AGENDA ITEM SUMMARY

Motion and Title: Staff recommends motion to approve: Change Order No. 4 to the contract with Cardinal Contractors, Inc. d/b/a Widell, Inc. for the Mecca Utility Site Project (R2005-1893) increasing the contract price by \$123,777 and providing a 30-day time extension.

PROJECT: BRP Utility Site

CHANGE ORDER NO.: 4 (Four)

SUBJECT: BRP Crane modification

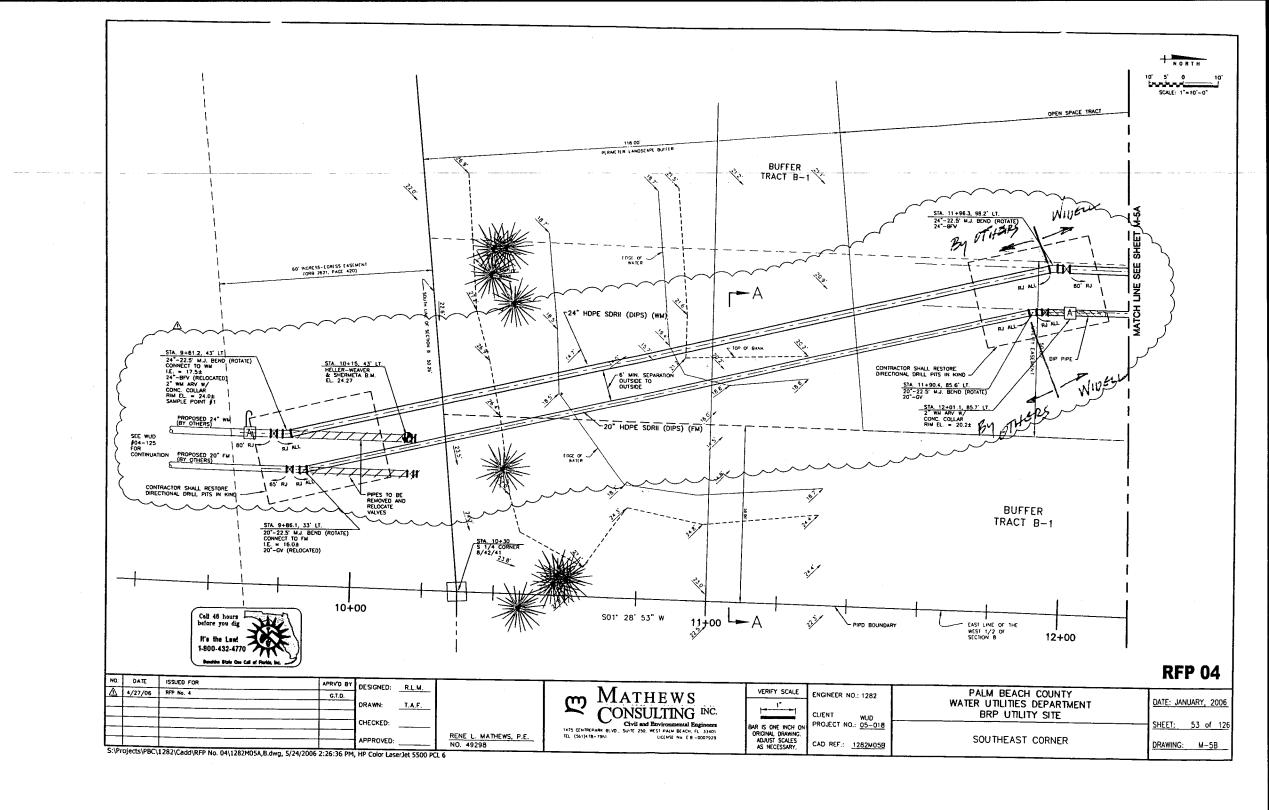
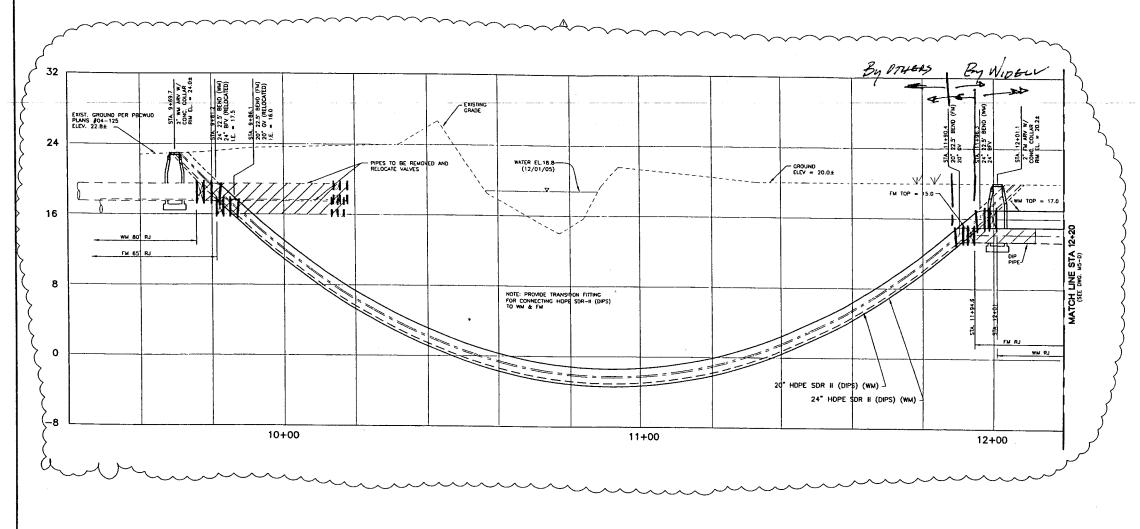
- Add extra runways sized for 23' support spacing (existing runways are sized for 19')
- Add runway rail.
- Supply embed plates
- Paint per specification.
 Add additional electrification
- Install and test.
- Pick up beams and deliver.

Price does not include modification to the building structure.

2 06-06-06 CRANE RAIL ADDED

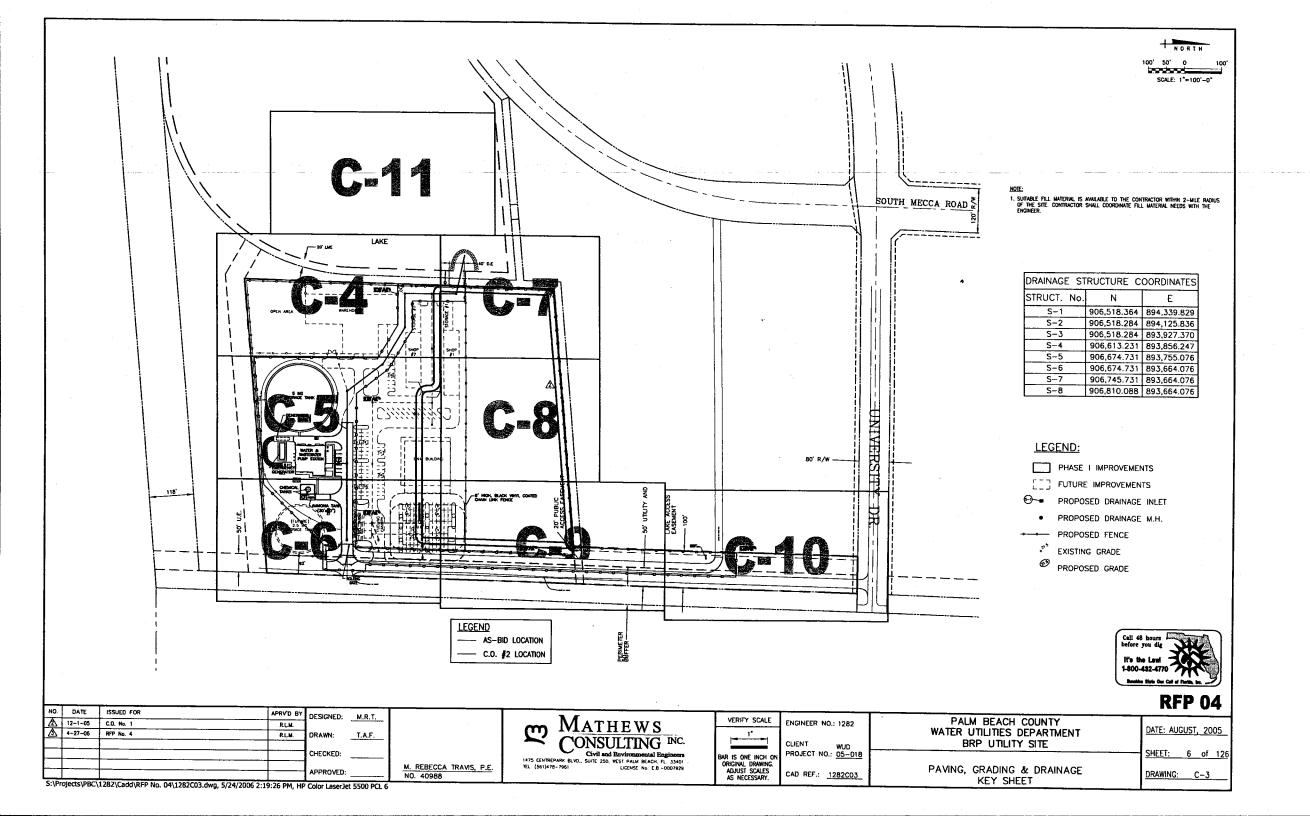
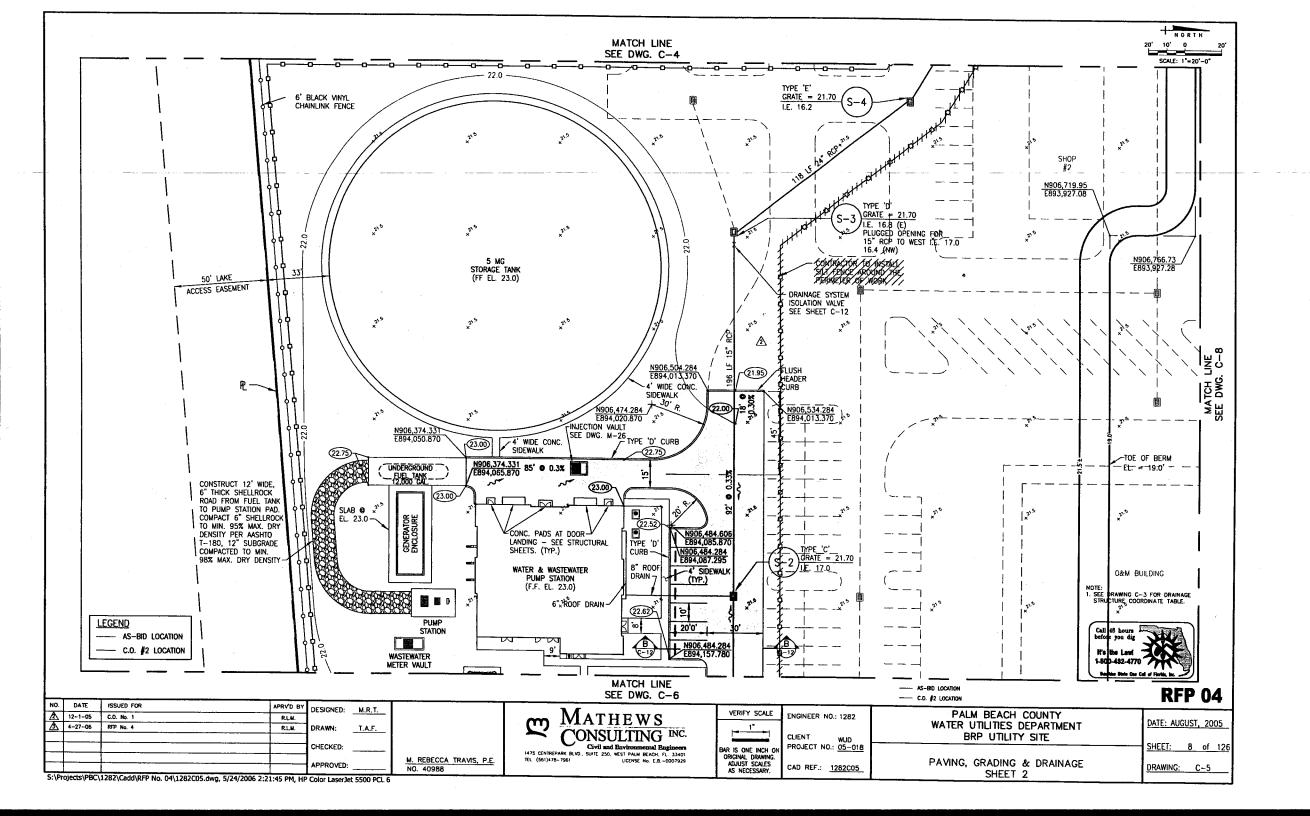
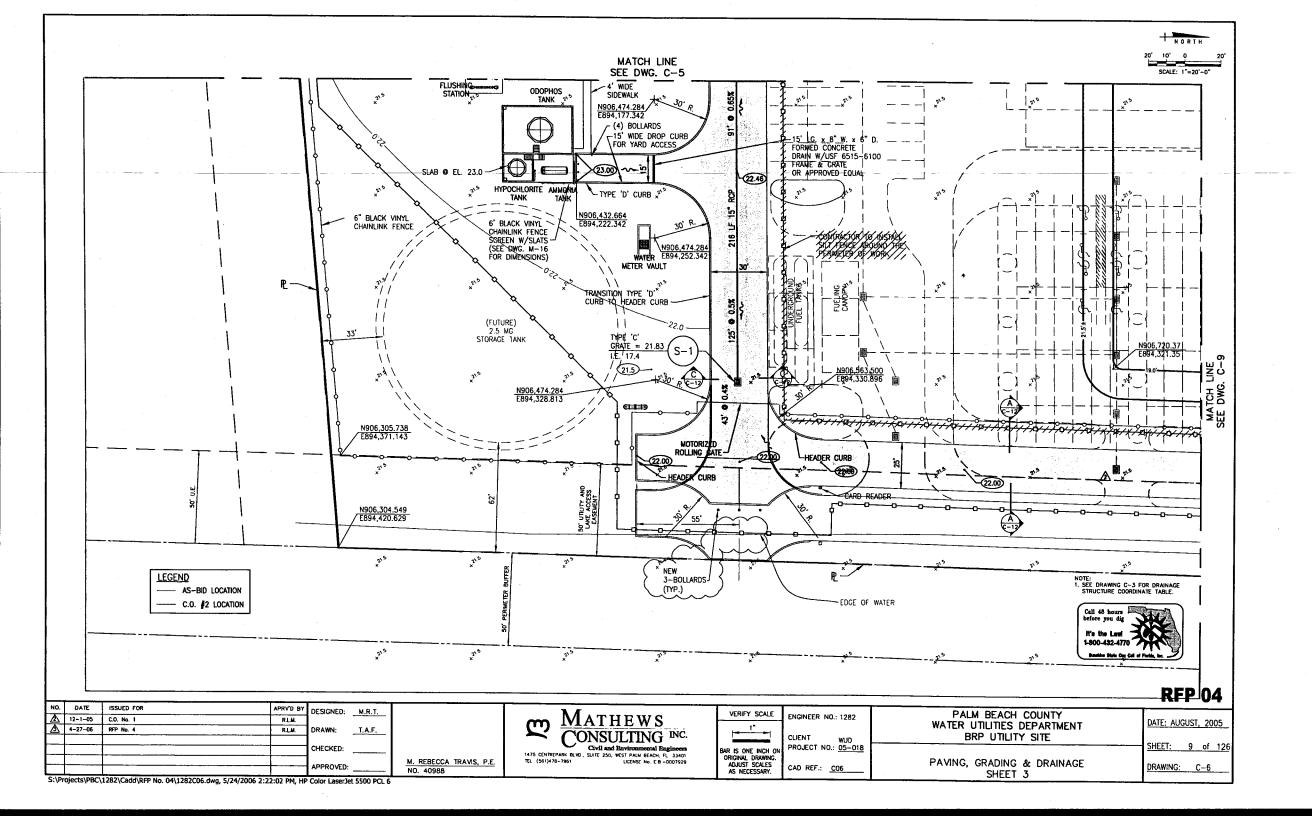
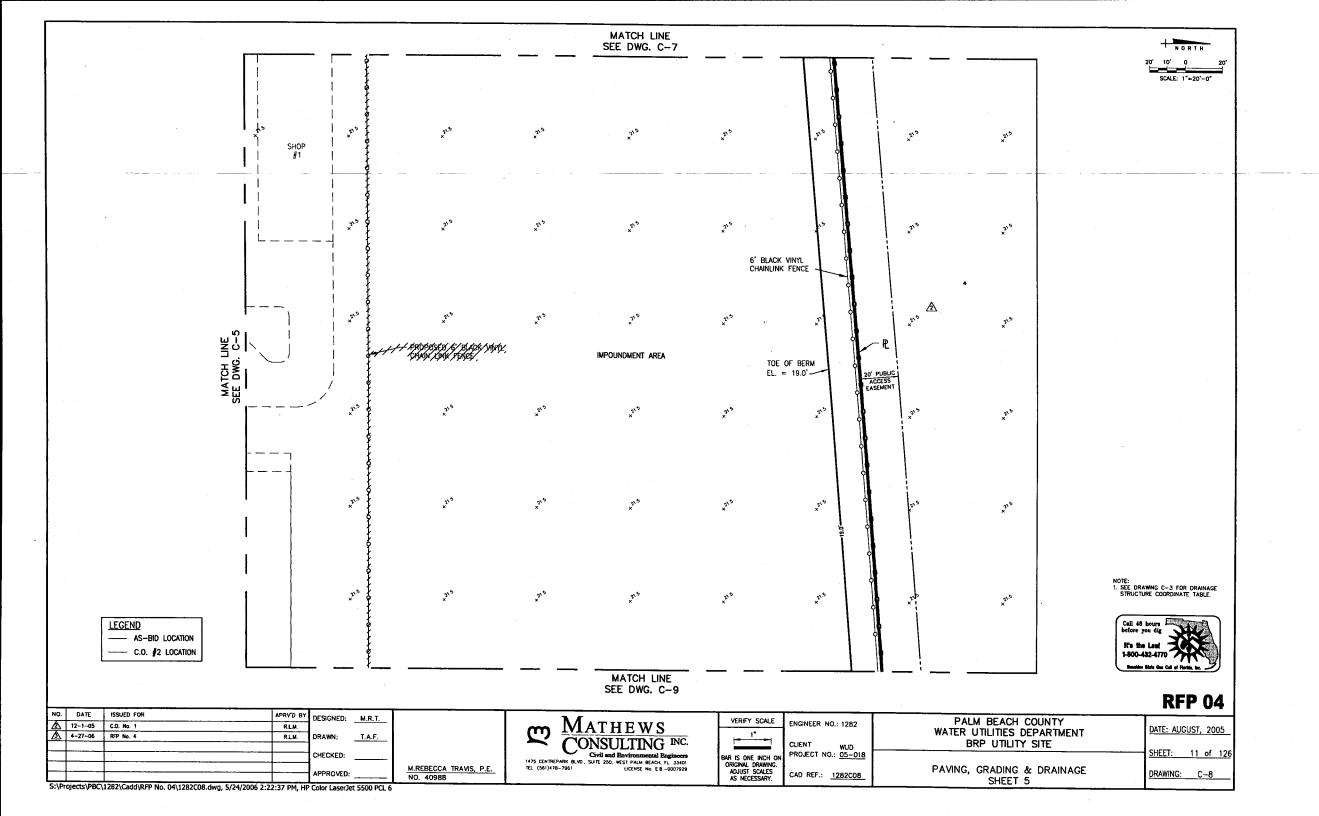
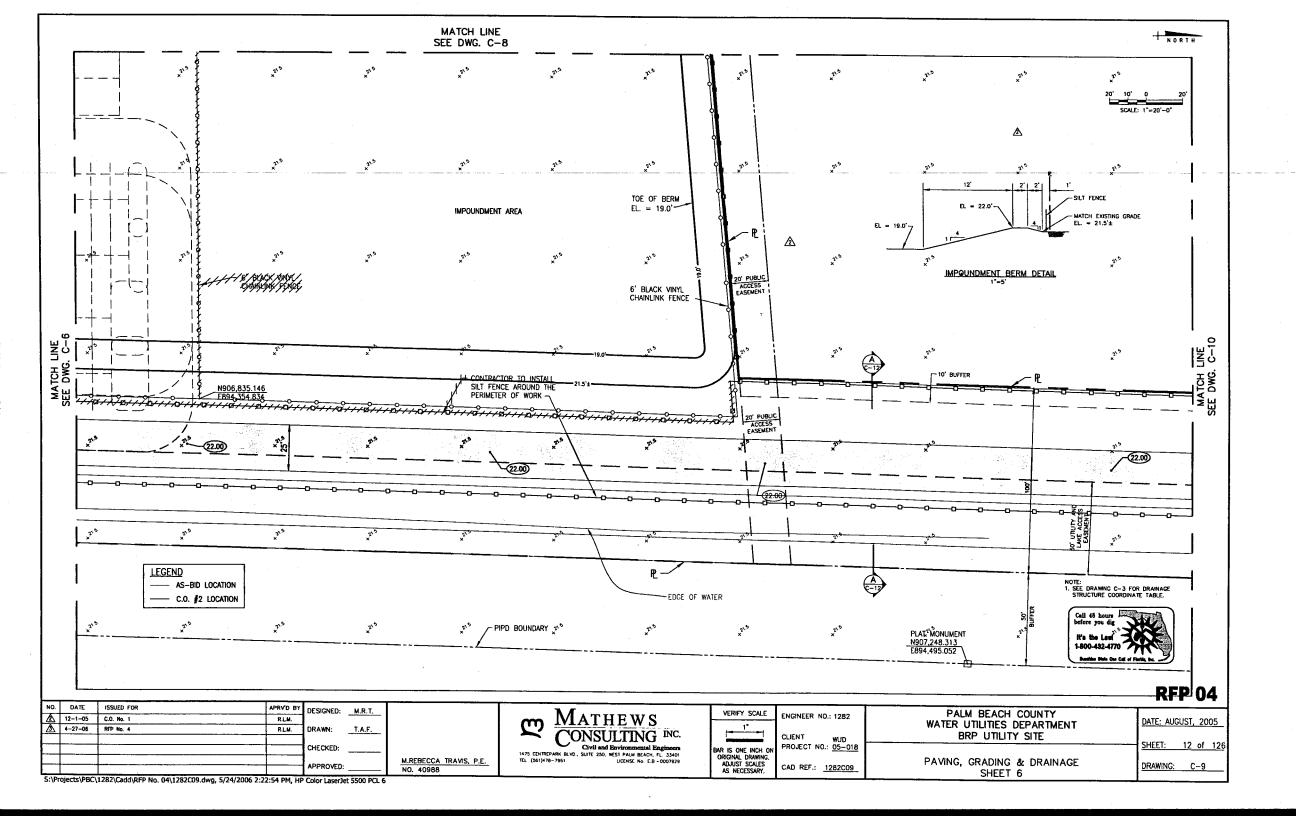
Request for Proposal #5 Crane Rail Modifications

- 1. Extend the crane support beam and crane rails to the full length of the pump room over the water pumps only. Additional sections can be added, rather than making them continuous.
- 2. Add #6 reinforcing bars to the east wall, in grouted cells.
- 3. Add corbels to columns at the east end.

DRAWING:	M-5C			
_	SHEET:	53	of	12	
i	DATE: APR	IL, 2	006	<u> </u>

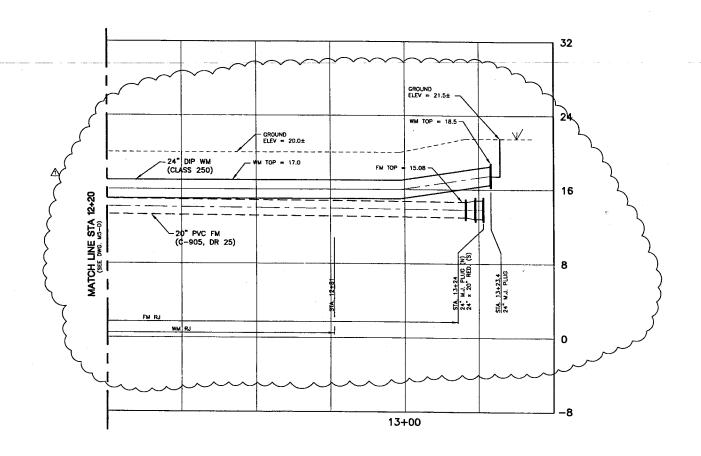
Prepare a revised quote based on deleting the directional drill from the original scope. Widell's scope will begin with the installation of the 22.5° bends on the 24" WM and on the 20" FM on the north end of the HDPE installed by directional drill by others. The drilled pipe will be left exposed above grade with caps to be removed and lowered to grade. Widell's scope will include the two north side gate valves and the ARV in manhole on the 20" FM. See mark up of drawings M-5B and M-5C. The remainder of the scope issued in January remains unchanged.

Please provide a proposal to make the following changes to the BRP Utility Site project as detailed on attached revised Drawings C-3, C-5, C-6, C-8, C-9, C-10, C-12, M-2, M-5, M-5A, M-5B, M-5C, M-6, M-7, M-8, M-9, M-10, E-4, E-7, E-8, E-9, E-10, E-11, and E-12 and new Specification 02345 (attached):

- 1. Shift site entrance drive approximately 20-feet to the west.
- 2. Shift motorized gate and fencing (including electrical components) and add three (3) new pipe bollards.
- 3. Connect site driveway to existing dirt access road. Delete approx. 400 feet of road and paving. Relocate Site Entrance Sign (including lighting for sign).
- 4. Shift the watermain and forcemain piping approx. 20-feet to the west as shown on the attached drawings.
- Install approx. 300 feet of 20-inch forcemain and 24-inch watermain piping, valves and appurtenances from Utility Site southeast property corner south to southeast corner of Mecca Farms. Approx. 100 feet of the piping shall be installed by means of Horizontal direction drill methods (refer to attached Spec. 02345).

- 6. Shift FPL and Bellsouth conduits & wire into the south side of the site to avoid conflict with new piping locations. Delete the FPL switch cabinet on Dwg. E-4.
- 7. Delete FPL conduit from entrance gate north to Proposed University Drive.
- 8. Delete site lighting from new access road north to Proposed University Drive.
- 9. Landscaping modifications shall be submitted at a later date.
